Re: First Nations Community Healthsource, Building C, BP-2019-31804
5608 Zuni Road SE, 87108
Request for Certificate of Occupancy
Transportation Development Final Inspection
Engineer's/Architect's Stamp dated 7-28-17 (L18D047)
Certification dated 04-25-19

SHEET TITLE
**ARCHITECTURAL
SITE PLAN FOR
TRAFFIC CIRCULATION
LAYOUT**

Re: **Permanent Certificate of Occupancy for**
Dental Addition: Building "C" Permit No.: BP-2018-31804
Address: 5608 Zuni Road, SE, Albuquerque, NM 87108

A1 ARCHITECTURAL SITE PLAN

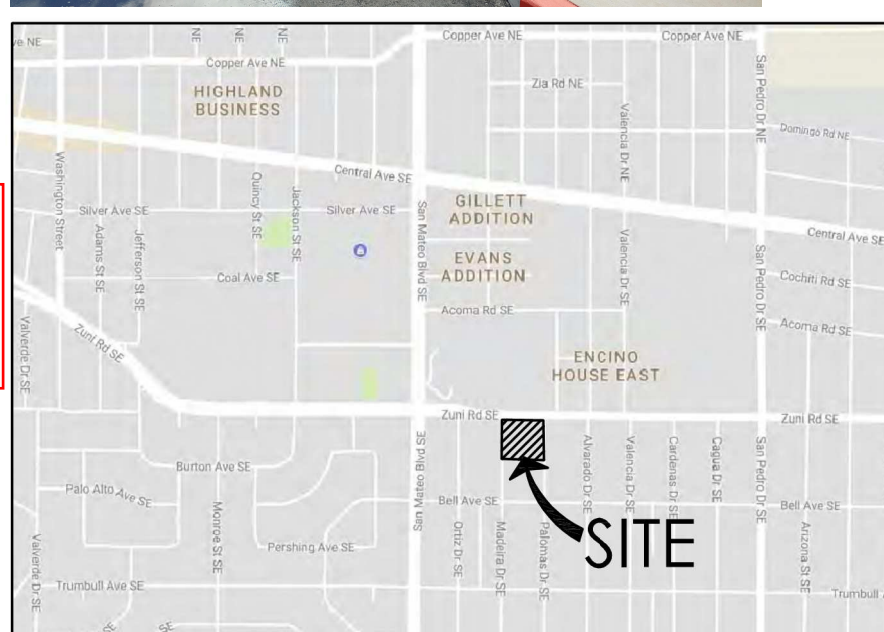
Concrete sidewalk was extended to drive aisle.
Concrete culvert and ROW sidewalk culvert approved with SO-19 permit.

Removed island as building did not need sprinklers/ FDC. Additional parking space was added.

HC parking spaces and aisle was moved one parking spaces south. See picture below.

Electrical Transformer was not relocated.

Electrical Transformer was not relocated.

Below grade overflow drainage pipe and ROW sidewalk culvert approved with SO-19 permit.
